**STAFF REPORT**  
**WEST ALLIS PLAN COMMISSION**  
**Wednesday, June 28, 2023**  
**6:00 PM**

- 4A. Conditional Use Permit for Caribou Coffee, a proposed Restaurant with accessory drive-through service, at 10200 W. National Ave.**
- 4B. Site, Landscaping, and Architectural Design Review for Caribou Coffee, a proposed Restaurant with accessory drive-through service, at 10200 W. National Ave. (Tax Key No. 485-9990-013)**

**Site Plan**

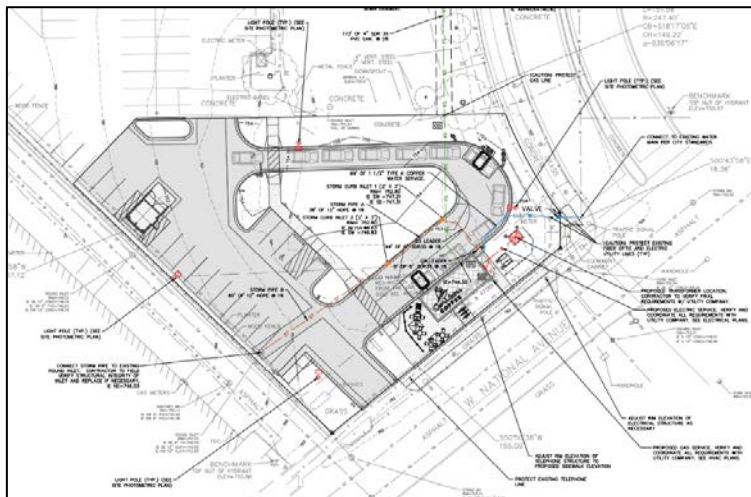
The proposed site layout includes 18 vehicle parking stalls (including 1 ADA stall) and 1 bicycle rack. The existing portion of the site includes 23 parking stalls and is legally nonconforming. Per code upon time of the application, restaurants were allowed the equivalent to 1 space per 40% of the building's occupancy. In this case, the maximum number of vehicle parking spaces would be 2. Per current code of 1 per 150 sq. ft., the maximum would be 4. Caribou is eligible for the less restrictive standard. The Plan Commission may approve the parking as is because it is a reduction in nonconformity or may condition a further reduction in parking. If Plan Commission desires a further reduction, staff would recommend removing the 3 parking spaces between the refuse enclosure and the northern lot in favor of landscaping.

The proposed drive-through is oriented around a central landscaping island. From the crosswalk leading to the north, the drive-through includes stacking for 10 vehicles; 6 to the order kiosk situated at the beginning of the curve and 4 to the pick-up window. A bail-out lane is included adjacent to the order kiosk. The City's Design Guidelines require that drive-throughs be located at the side or rear of the building, which this proposal adheres to. It also requires driveways for drive-throughs be located as far as possible from street intersections and be located on secondary streets for corner lots. This lot's driveway is pre-existing on the main street but is located far from the intersection. Staff recommends maintaining this site layout as proposed.

### Landscaping Plan

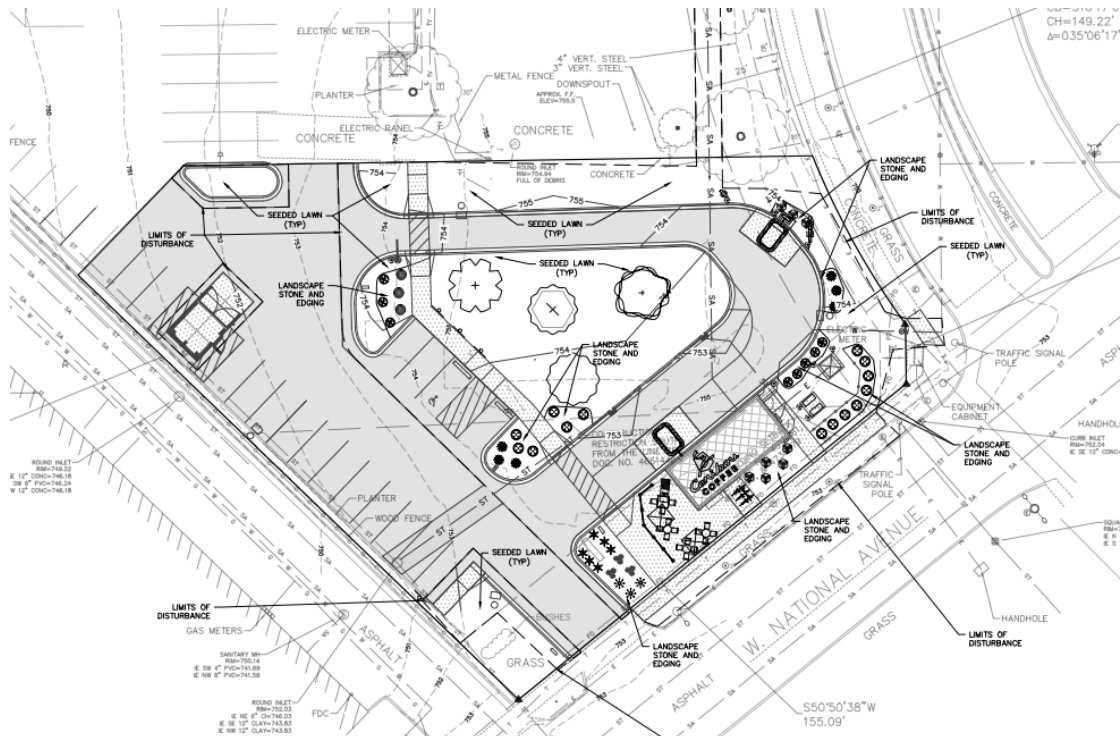
Plantings include deciduous shrubs and perennial flowers near the building, arborvitae to screen the drive-through and service door from W. National Ave., and trees and other shrubs in the central landscaped island. City Forestry recommends additional landscaping along the North edge of the property and updated scaled drawings to better determine spacing and quantity of plantings.

1. Common Council approval of the Conditional Use Permit.
2. Common Council approval of a Certified Survey Map to split parcel into 2 lots.
3. Revisions to Site, Landscaping, and Architectural plans showing a) additional landscape plantings along the north side of the property; b) scale drawings of landscape beds; c) landscaping species plan approved by City Forestry; d) sidewalk alignment for connection with property to the north.
